Re: Addendum Soil and Ground-Water Investigation Work Plan
Atlantic Richfield Company Station #498
286 South Livermore Avenue
Livermore, California
ACEH Case RO0002873

Re: Addendum Soil and Ground-Water Investigation Work Plan, Atlantic Richfield Company
(a BP affiliated company) Station #498, 286 South Livermore Avenue, Livermore,
California. Case No. RO0002873.

enclosure: Drawing 1: Addendum Site Map with Historic and Proposed Sample Locations

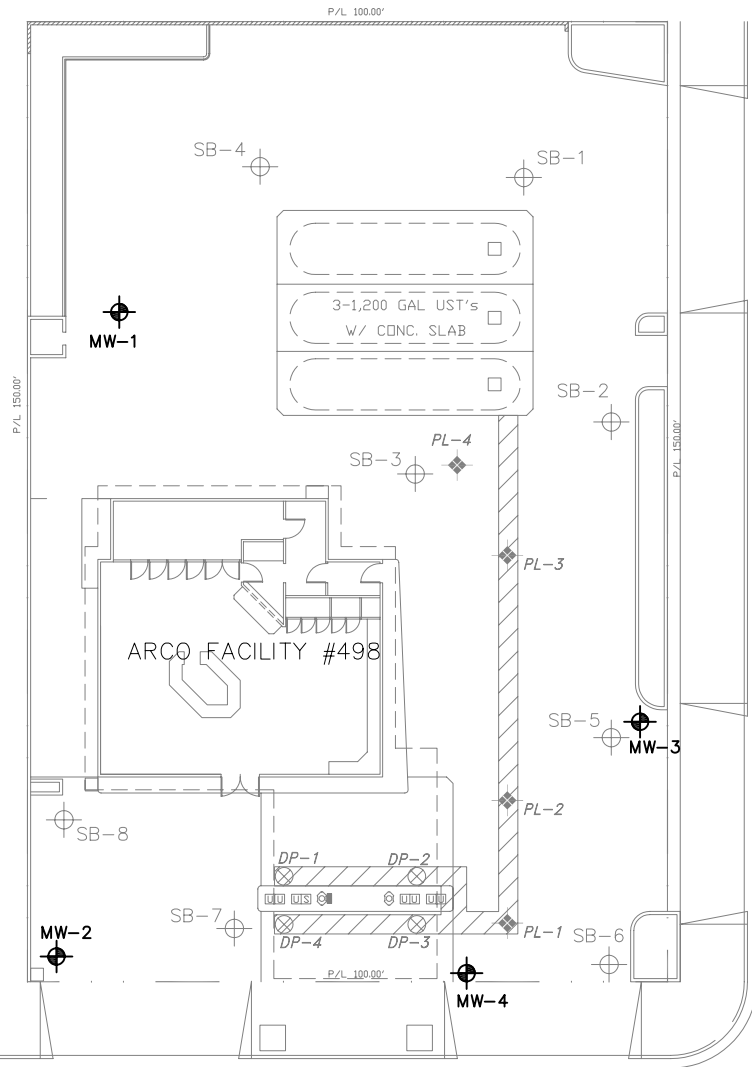
Provided herein is an addendum to the Broadbent and Associates, Inc. (BAI) September 2, 2008 *Soil and Ground-Water Investigation Work Plan* (herein referred to as the Work Plan). In response to the Work Plan, the Alameda County Environmental Health (ACEH) issued the September 17, 2008 letter stating, "to adequately characterize the soil and groundwater in the vicinity of soil sample DP-3, an additional monitoring well located in line and approximately midway between proposed MW-2 and SB-6 appears necessary."

Accordingly, additional monitor well MW-4 will be installed at the location depicted in Drawing 1. Proposed well location MW-3 has been moved approximately 25 feet to the northeast (from the original location included in the Work Plan) to provide adequate distance between wells MW-3 and MW-4. Soil sampling and well construction details for MW-4 will be the same as details provided in the Work Plan for wells MW-1 through MW-3.
